SECOND AND THIRD READING SUMMARY SHEET**NEIGHBORHOOD PLAN CASE NUMBER:**

NP-07-0024 – North Burnet/Gateway Master Plan –City Initiated

ADDENDUM

The following changes shall be made to the North Burnet/Gateway Master Plan:

p. 4:10 & 4:26, Figures 4.9 and 4.22: Proposed Subdistrict Plan

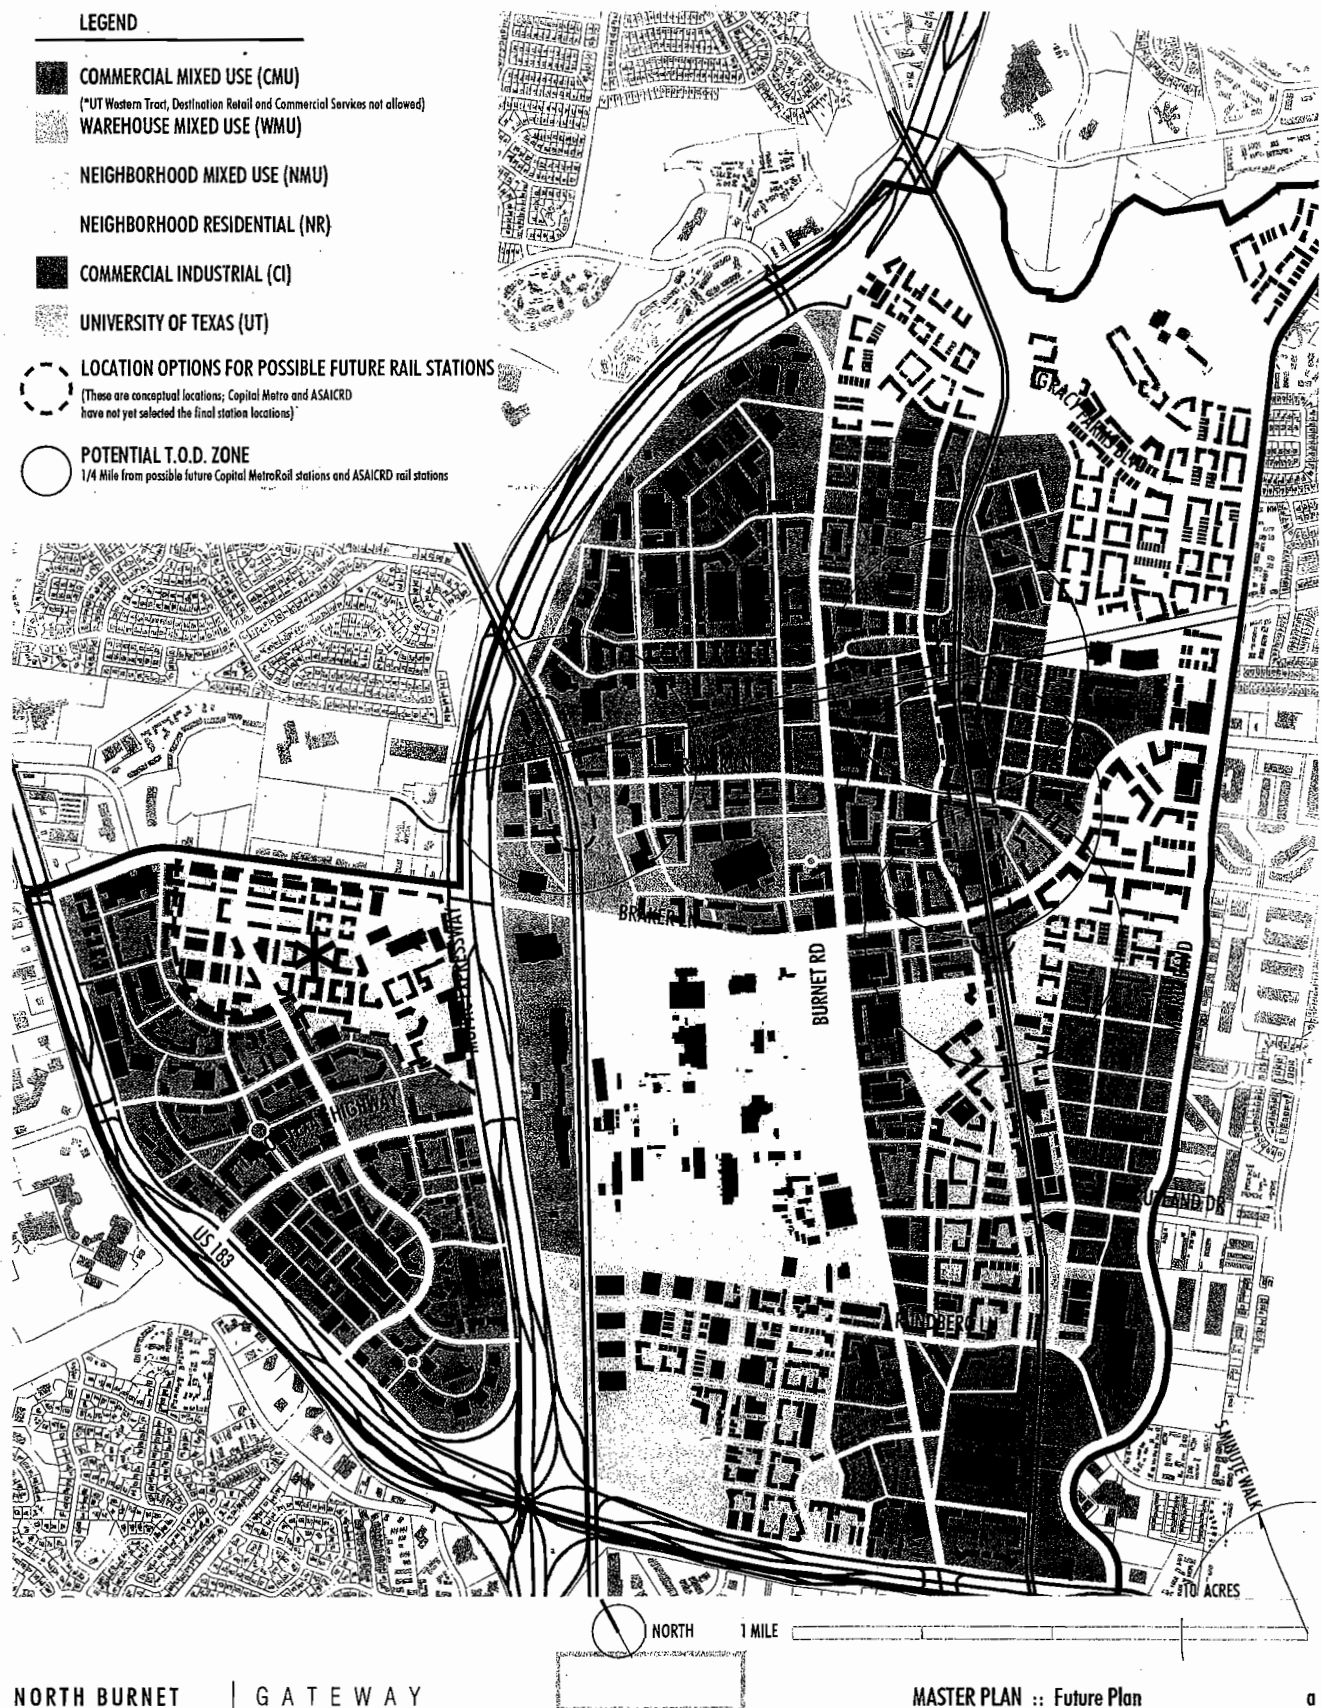
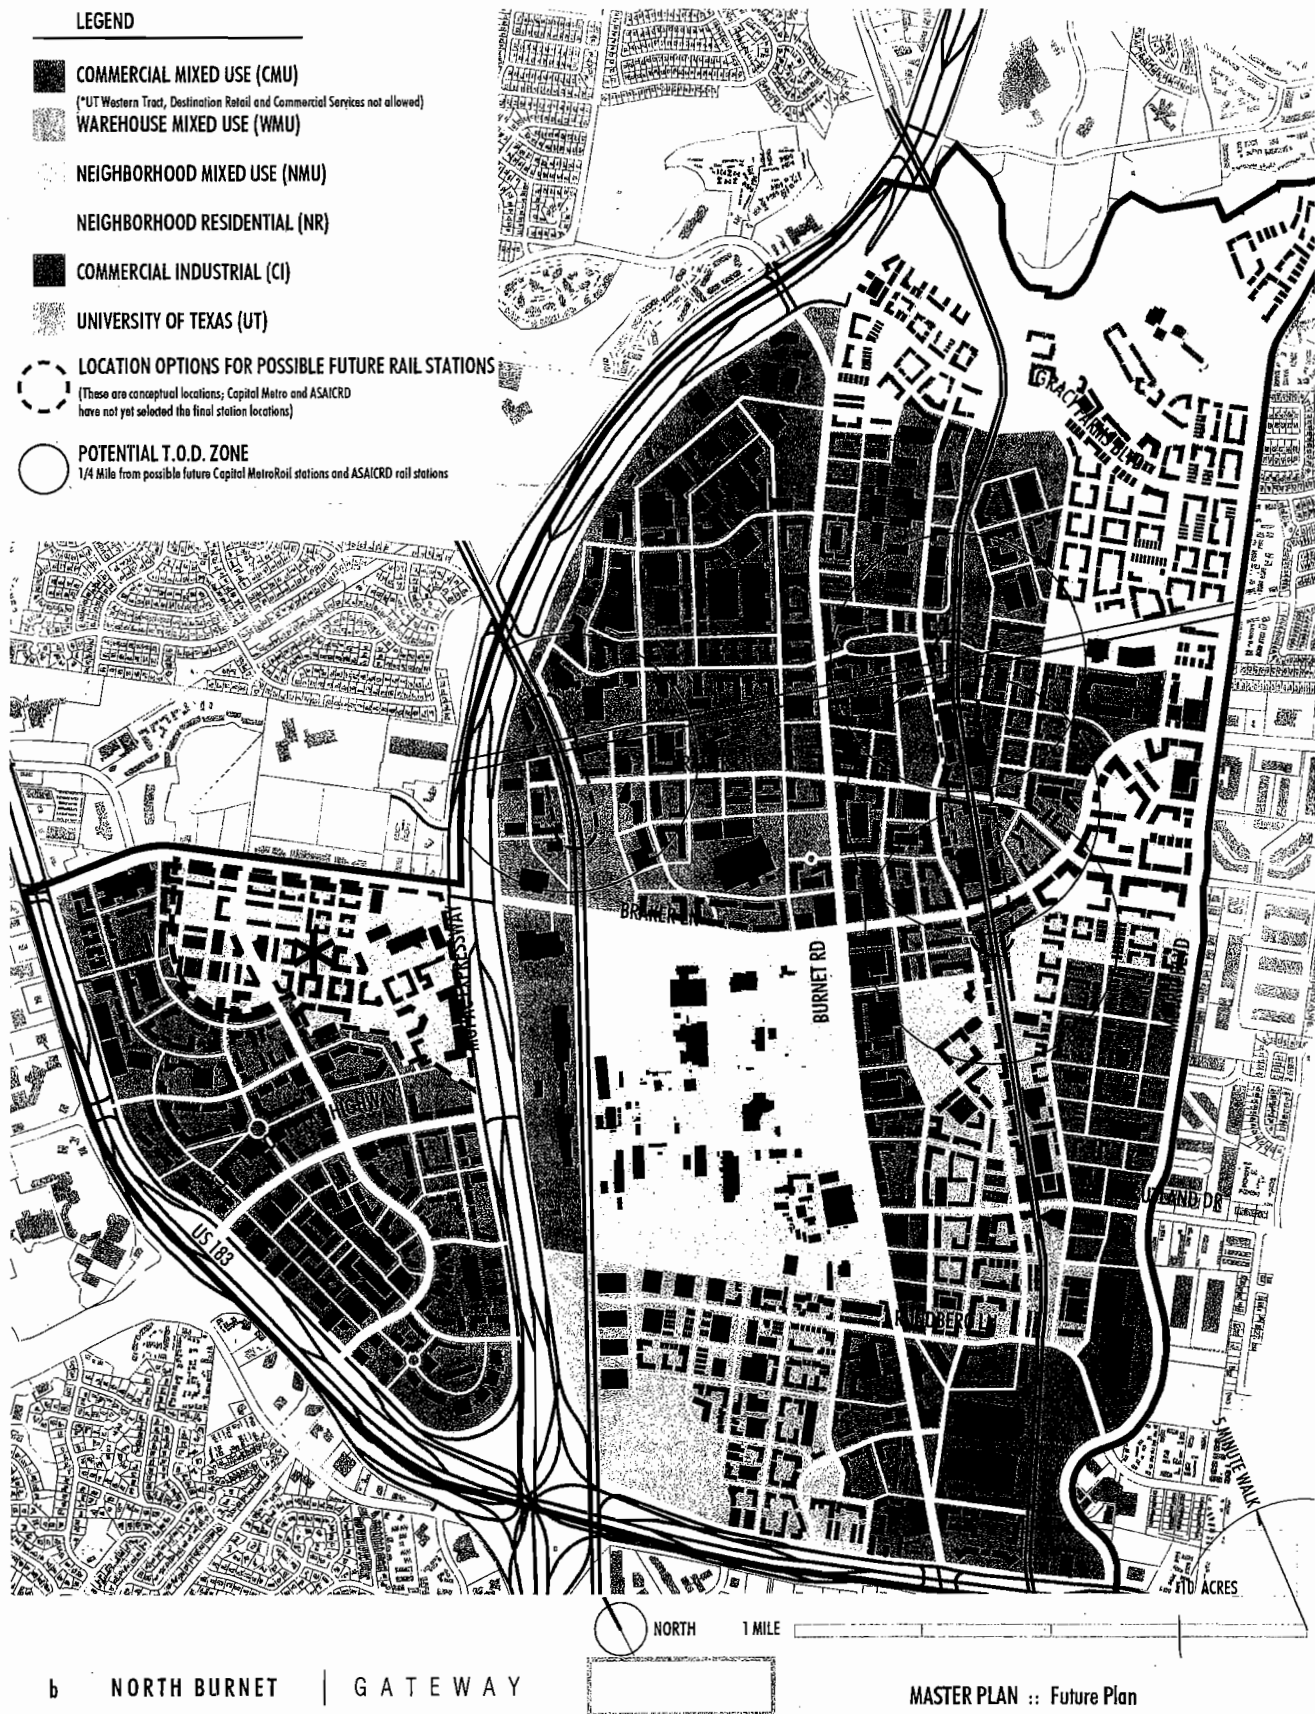
[See attached revised Figures 4.9 and 4.22: Proposed Subdistrict Plan. These figures have been revised to identify the University of Texas Western Tract as part of the Commercial Mixed-Use subdistrict, but Destination Retail and Commercial Services will not be allowed.]

NORTH BURNET/GATEWAY MASTER PLAN - REVISED FIGURE 4:36 SUBDISTRICT DEVELOPMENT STANDARDS SUMMARY

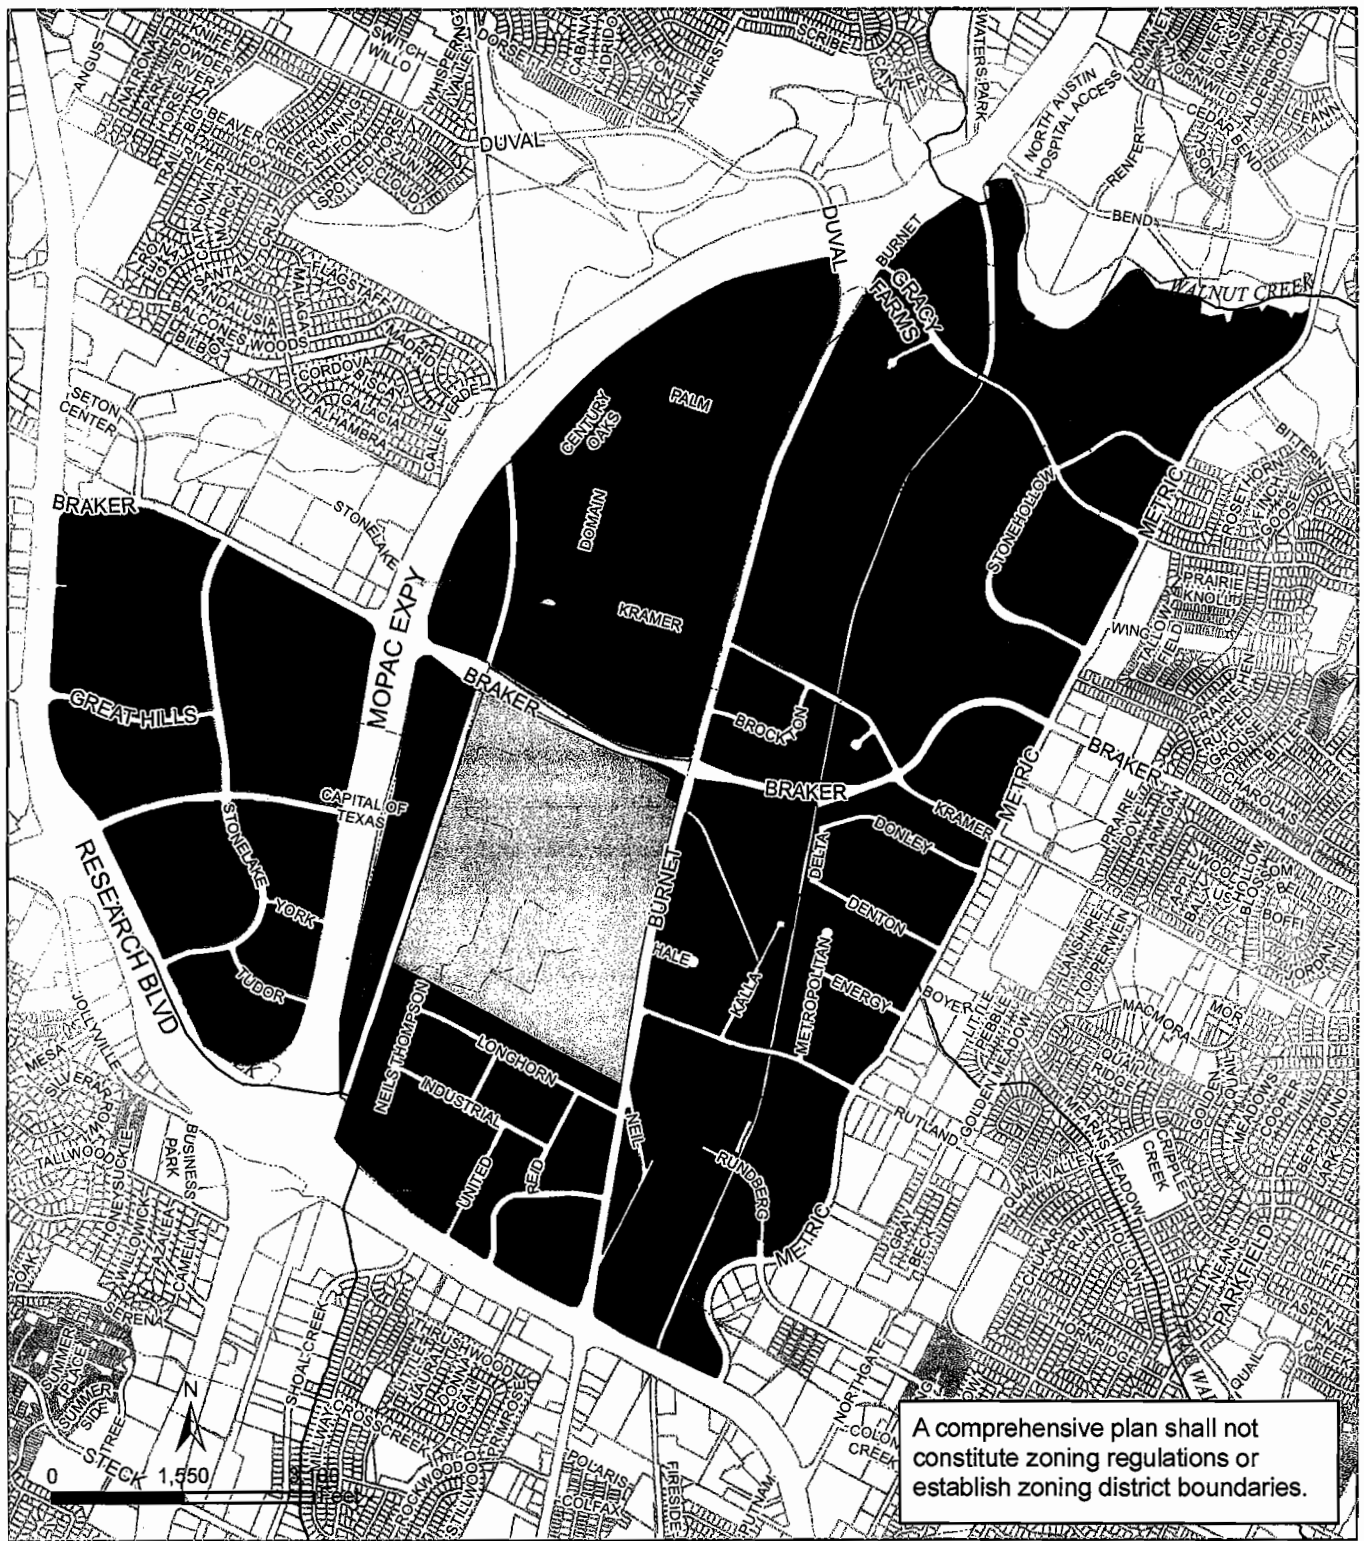
[See attached revised Figure 4.36. This figure has been revised to identify the University of Texas Western Tract as part of the Commercial Mixed-Use subdistrict, but Destination Retail and Commercial Services will not be allowed. In addition, the Min. Parking Standards for all subdistricts has been reduced to 30% of Appendix A (City of Austin Land Development Code Section 25-6 Appendix A Tables of Off-Street Parking and Loading Requirements).]
